PROJECT: Silver Spring Green Trail
From Fenton Street to Sligo Creek Parkway
C.I.P. No. 509975

REVIEW TYPE: Mandatory Referral No. 01814-DPW&T-1

RECOMMENDATION: APPROVAL WITH COMMENTS TO DPWT

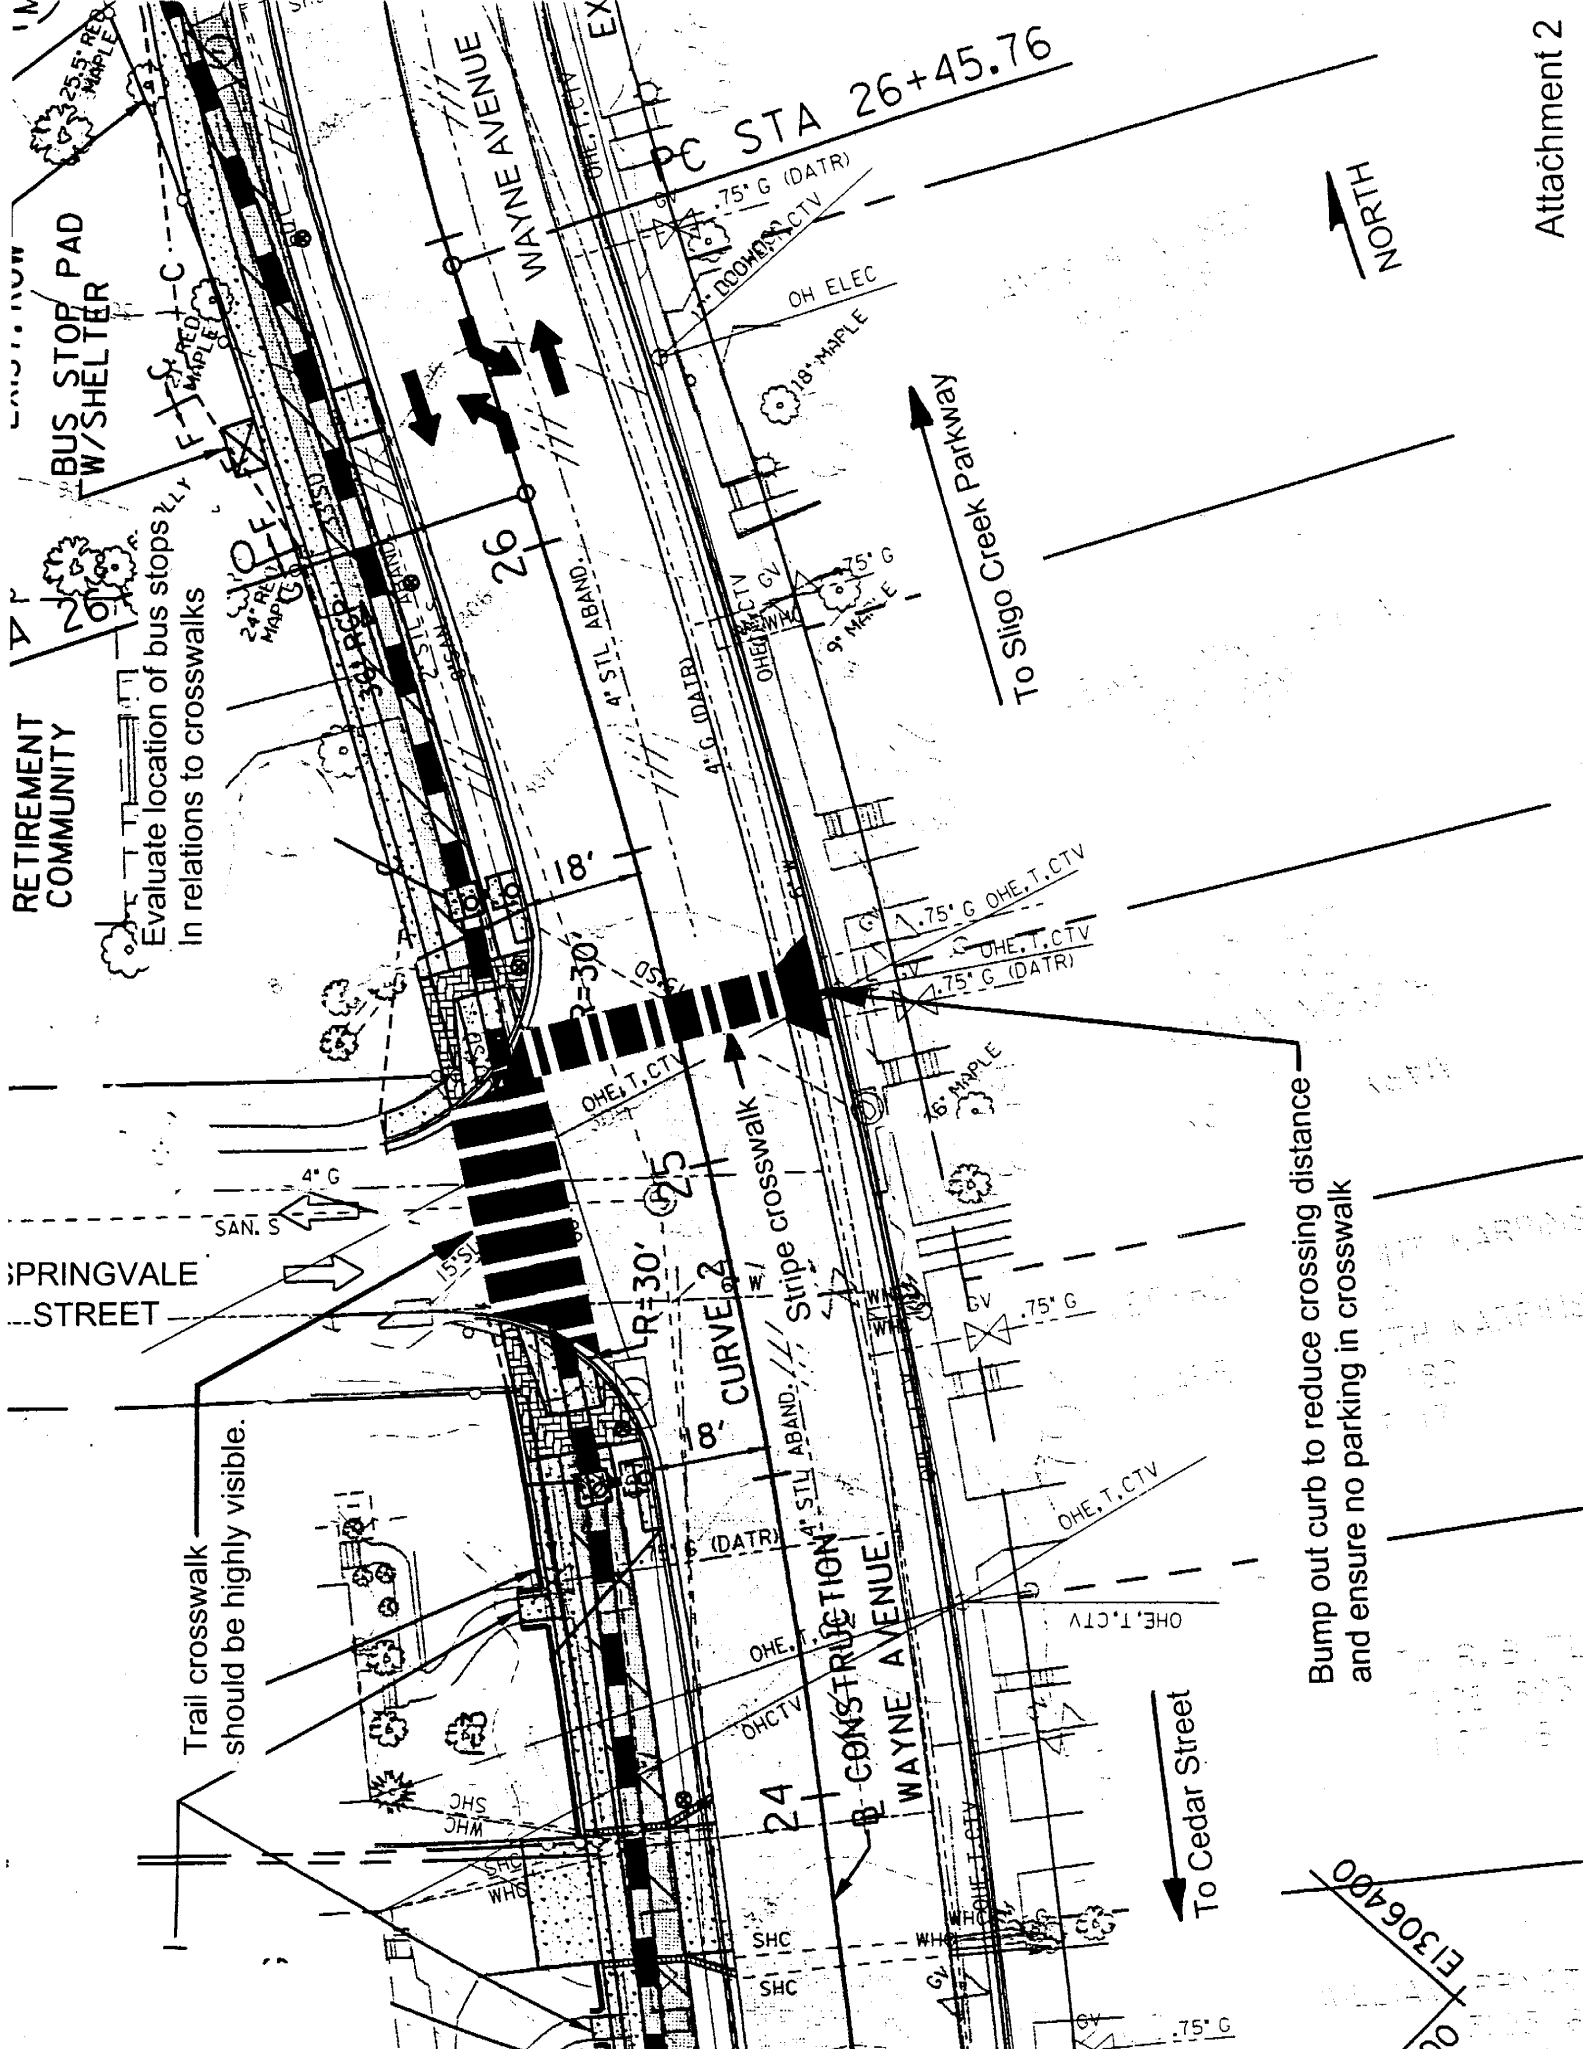
Evaluate location of bus stops in relations to crosswalks

Trail crosswalk should be highly visible.

Stripe crosswalk

Bump out curb to reduce crossing distance and ensure no parking in crosswalk
